ALERT SERVICE BULLETIN ASB UH-1H-II-24-36

MODEL AFFECTED: UH-1H-II

SUBJECT: MAIN BEAM CAP ANGLE, P/N 205-830-036-119,
INSPECTION OF.

Figure1. Fuselage Tailboom Attachment Inspection.

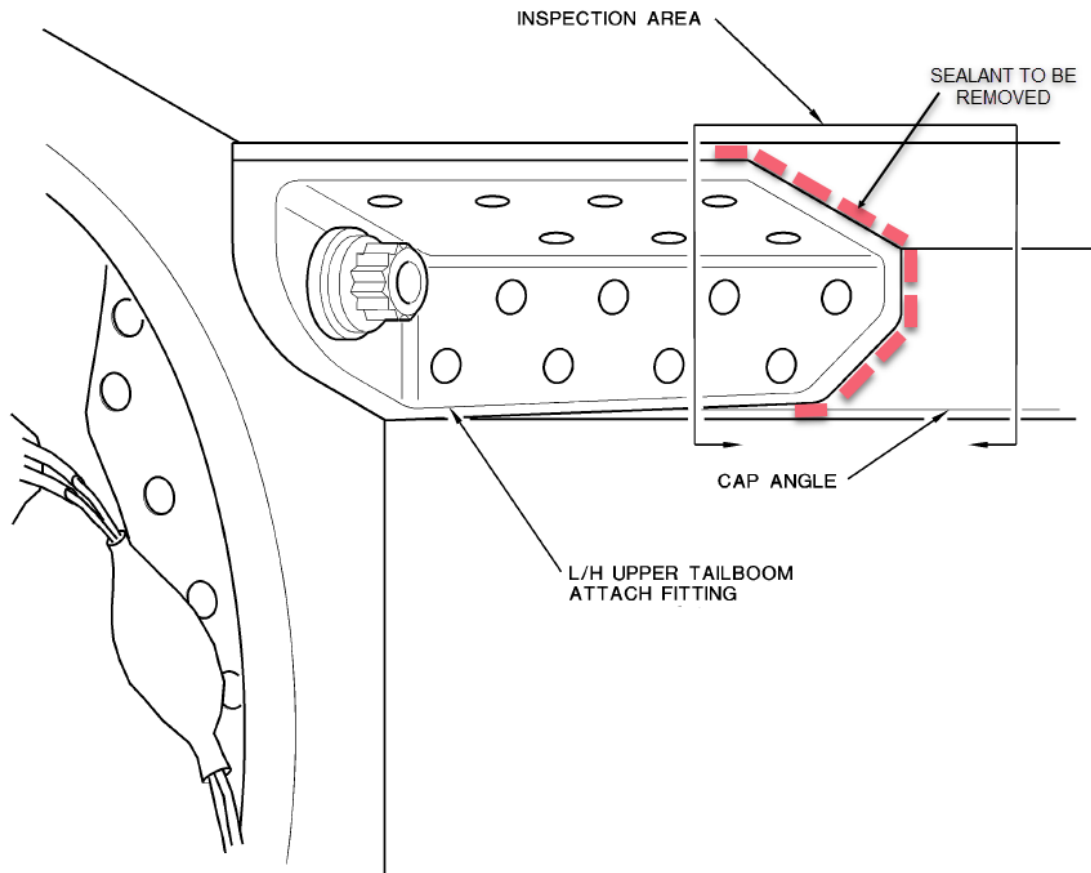
2. Remove sealant from edge of fitting (Refer to Figure 1).
3. Inspect the cap angle area shown in Figure 1 with a 10x magnifying glass and bright light.
4. If a crack is found, replace the cap angle before further flight. If no cracks are found, continue with Step 5.
5. Touch up primer and paint, if damaged during sealant removal, and allow to dry. Do not reapply sealant.
6. Ensure work areas are clean and secure. [QA]
7. Make an entry in the helicopter logbook and historical service records indicating findings and compliance with this Alert Service Bulletin.
